Technical BULLETIN

2006 FJR1300AV, AVC

Incorrect Display of Instantaneous Fuel Consumption

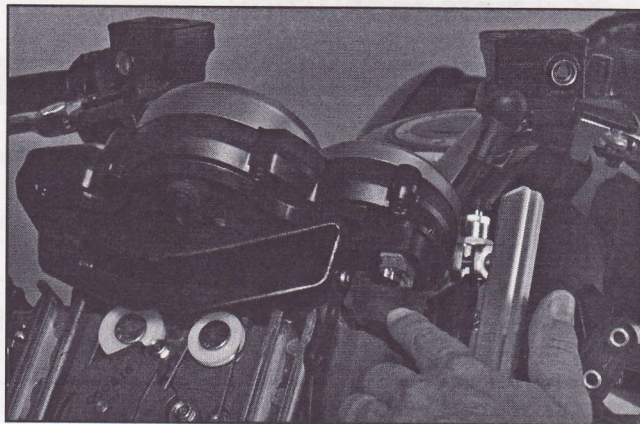
NOTE: New and old meters can be identified by the label on the back of the meter housing (see lower adjacent illustration).

10. Install the new meter.
